Subject: Review meeting 7/16/19 Lavitt property PV Planning from Phil Hagenah

Re: Preliminary Plat for Lavitt Manor II—Two Lot Subdivision: 7525 N. Ironwood Drive

5. PUBLIC HEARINGS 19-302 CONSIDERATION OF PRELIMINARY PLAT

DRAWING NO:
C20f3

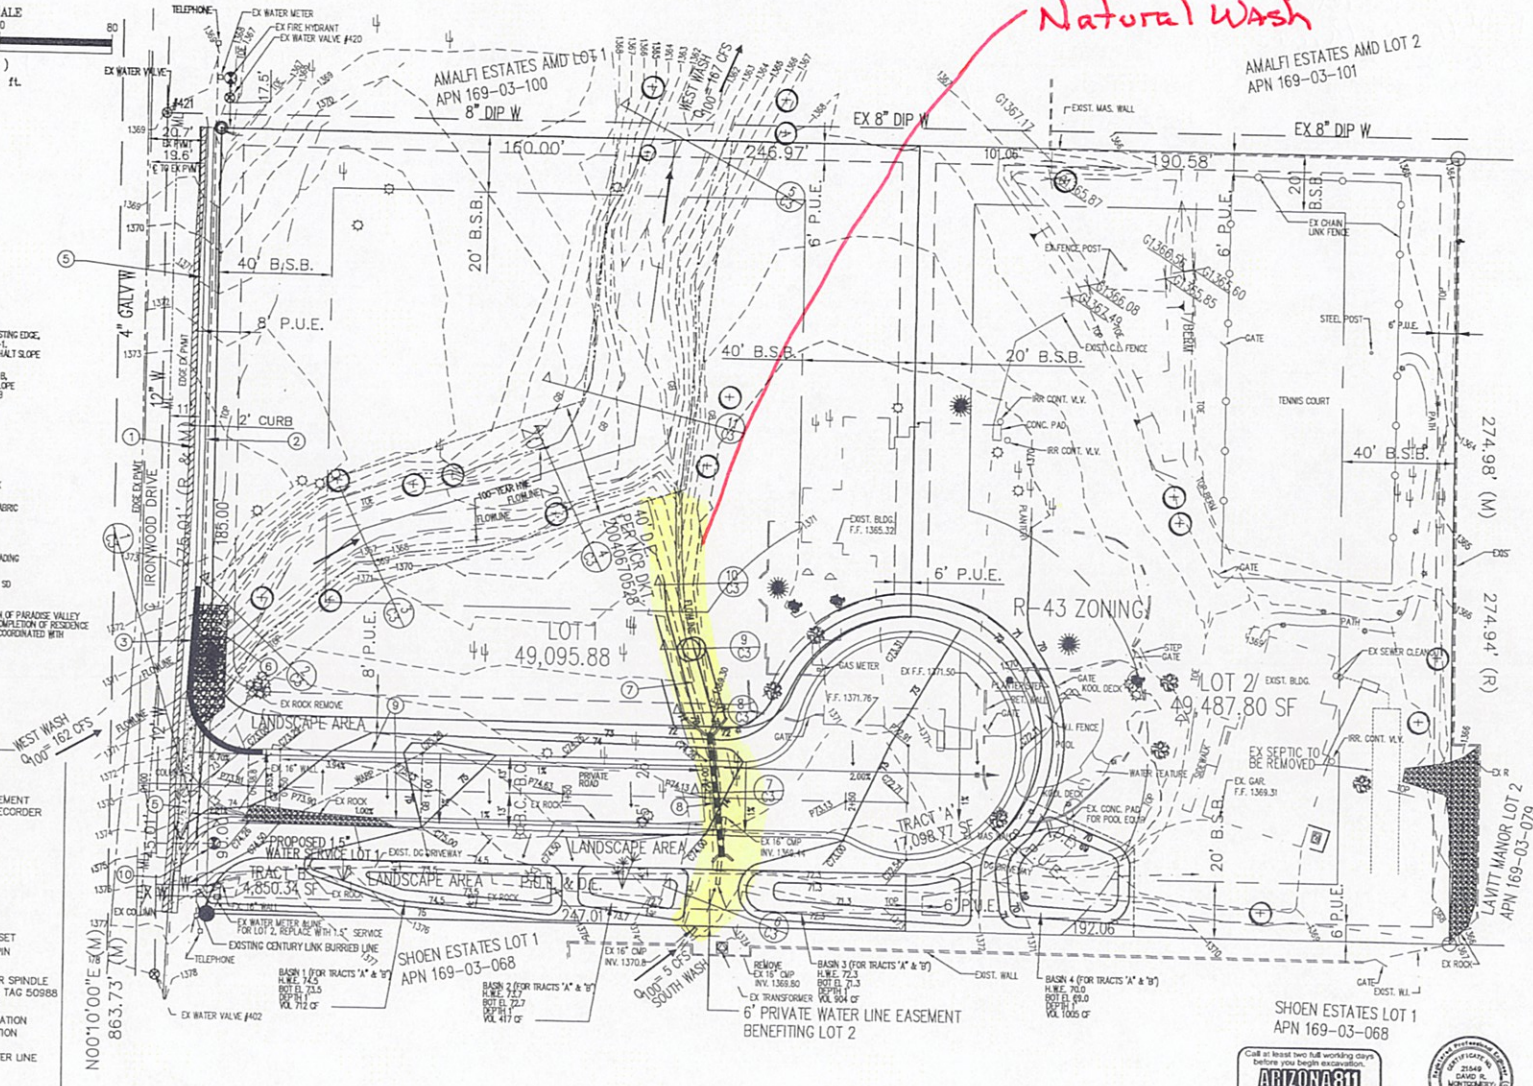
Does NOT show REQUIRED Landscape Buffer here or on plat 3-6(3) STORM DRAINAGE Design Manual

Suspected
Natural Wash

Did NOT provide LANDSCAPE BUFFER OR
EQUALLY SPACED CROSS SECTION ACROSS ENTIRE WASH

DRAINAGE 3-6(2)
DRAINAGE 3-6(3)
PV CODE 5-10-7
PV CODE 6-3-8

DRAWING NO:
C20f3

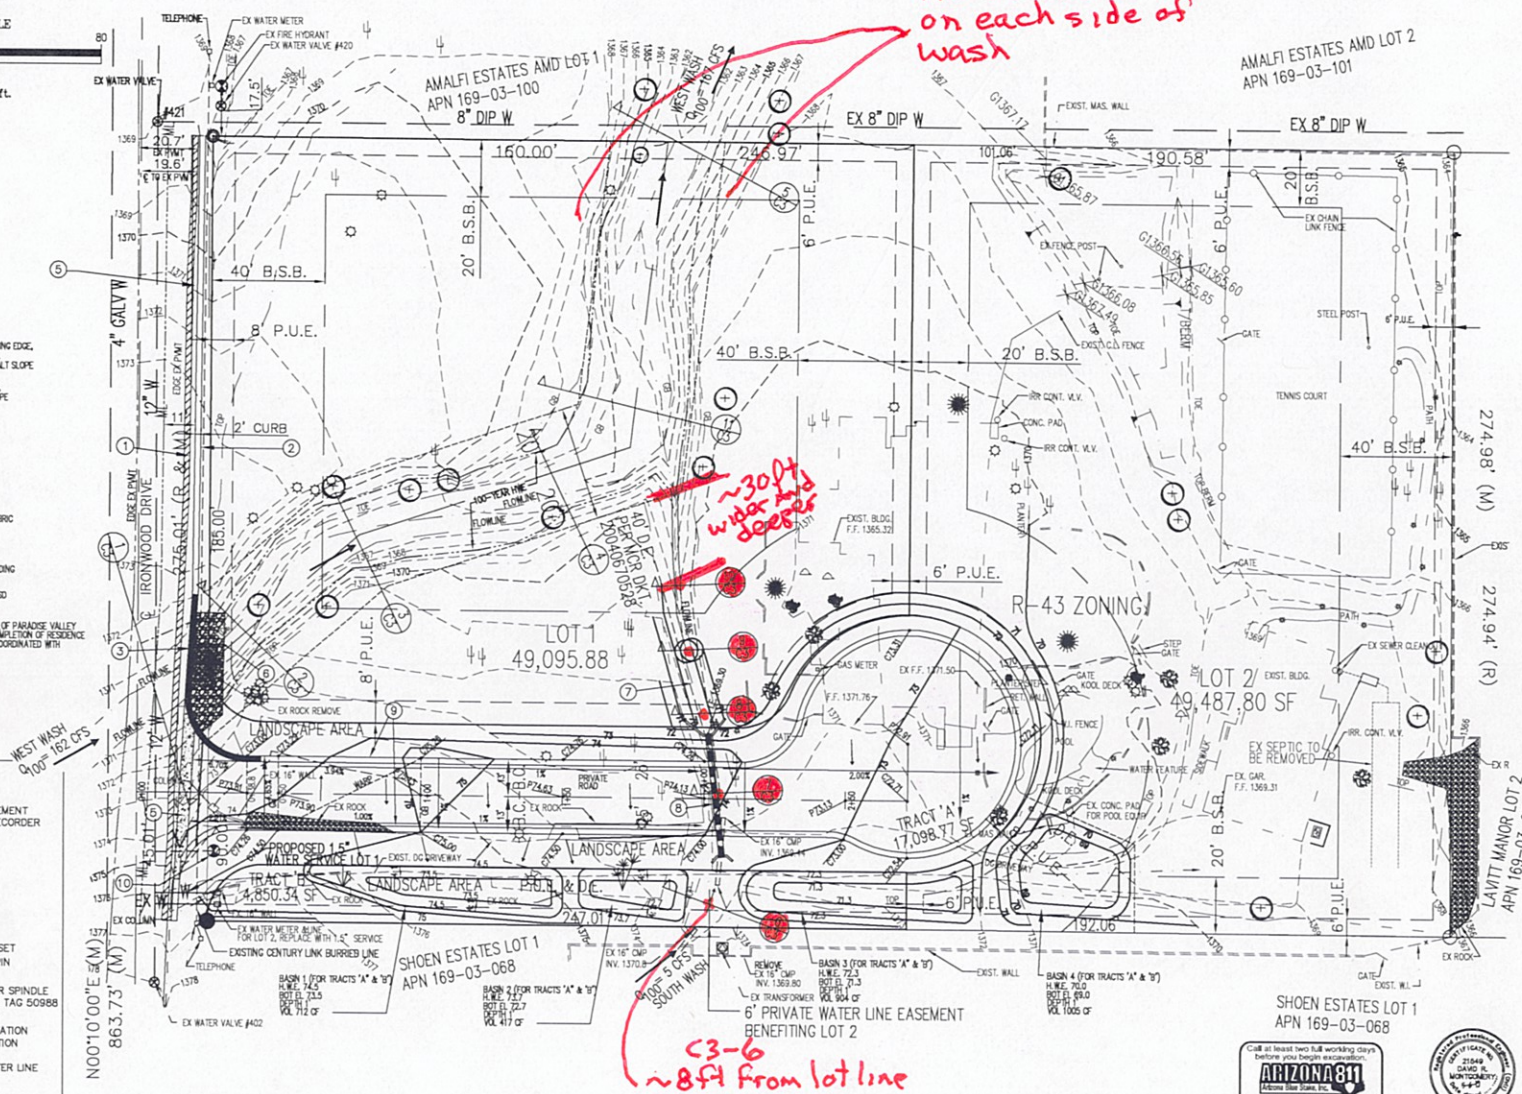
no buffer of 5'
on each side of
wash

~30ft
wider and
deeper

C3-6
~8ft from lot line

DRAWING NO.
C30f4

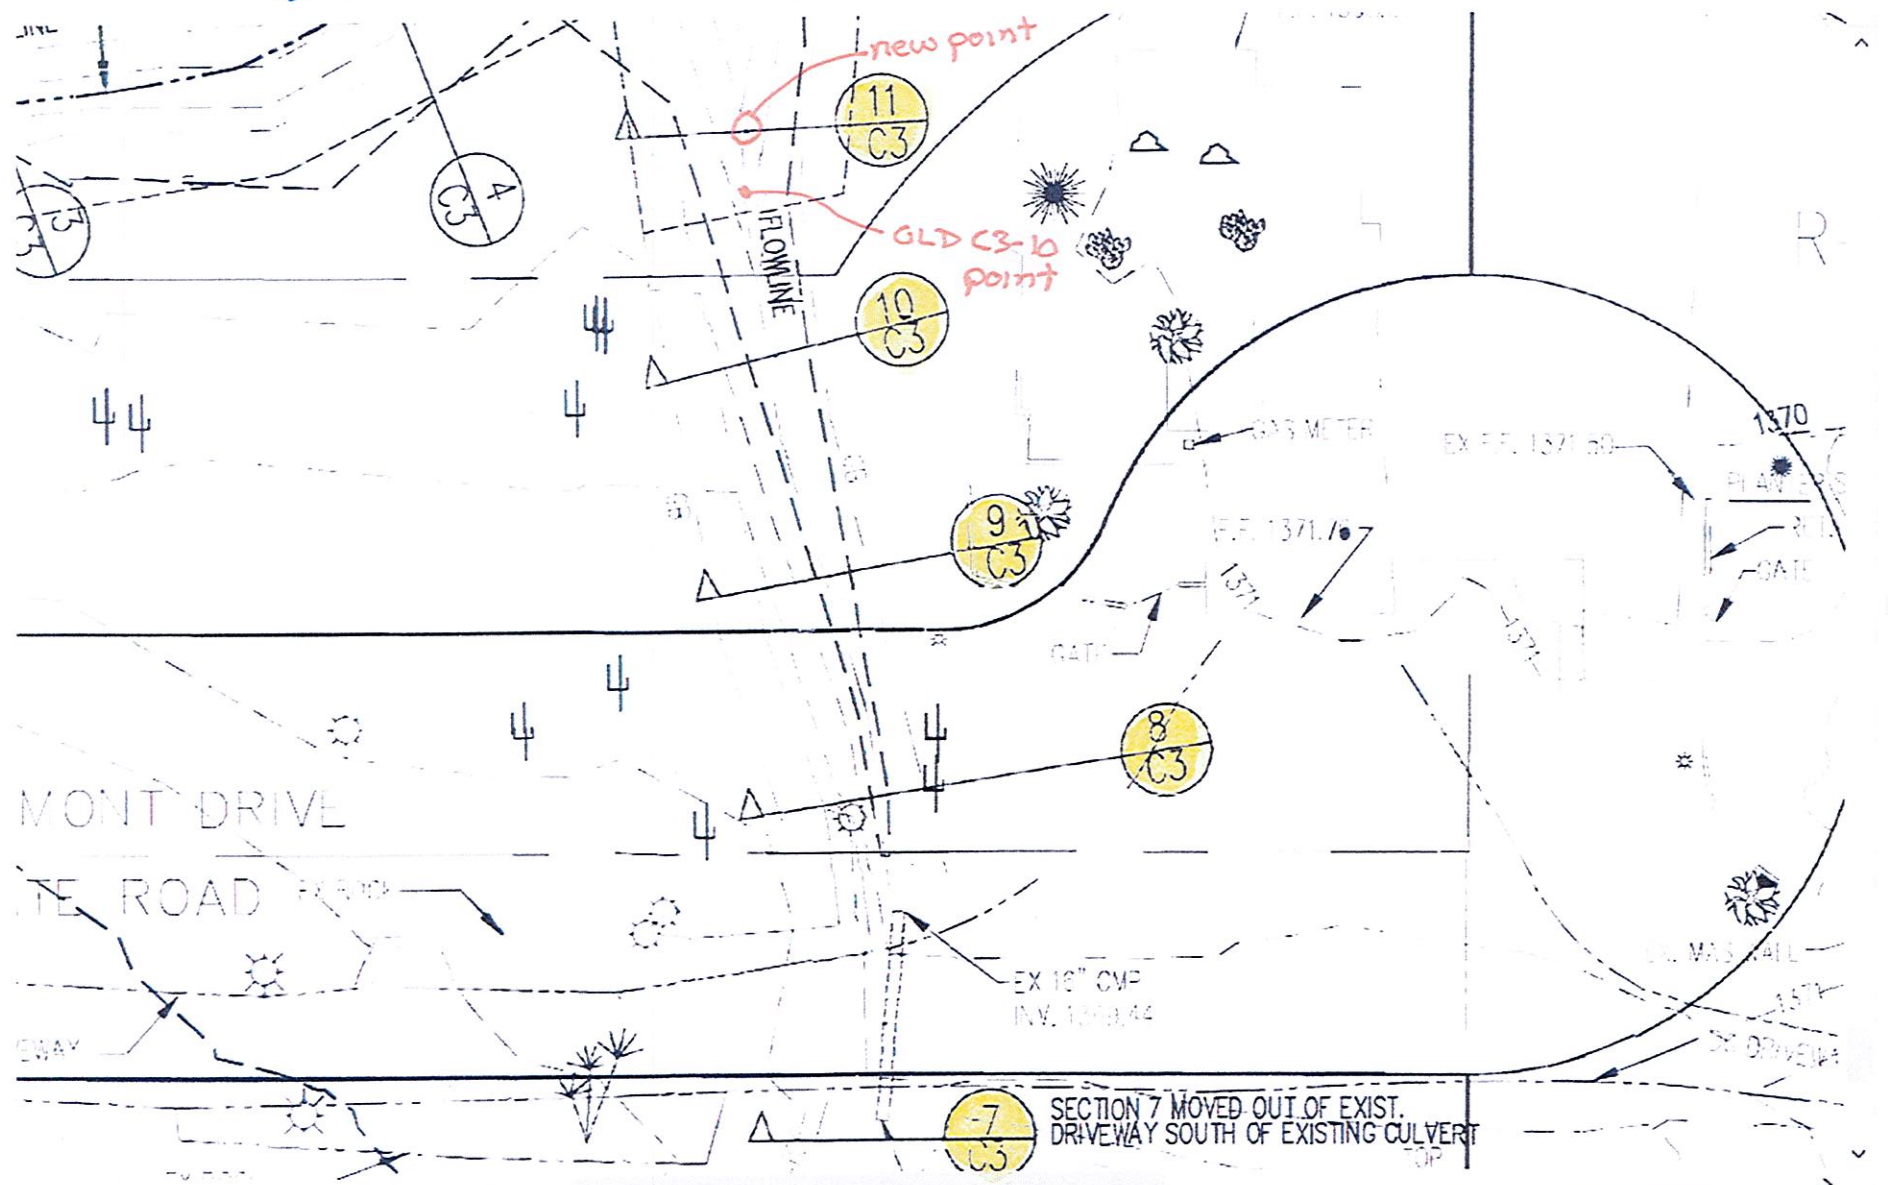
**SUMMARY OF PLAT POINTS
FOR
SOUTHERN DRAINAGE CHANNEL**

Plat Points	Elevation Pt. 1	Elevation Pt. 2	Depth of Wash	Width of Wash
C3-7	1373.2	1369.8	3.4 feet	18.5 feet
C3-8	1373.0	1369.7	3.3 feet	8.5 feet
C3-9	1372.0	1369.6	2.4 feet	10.6 feet
C3-10	1371.0	1369.3	1.7 feet	12.0 feet
C3-11	1370.1	1368.2	1.9 feet	14.0 feet
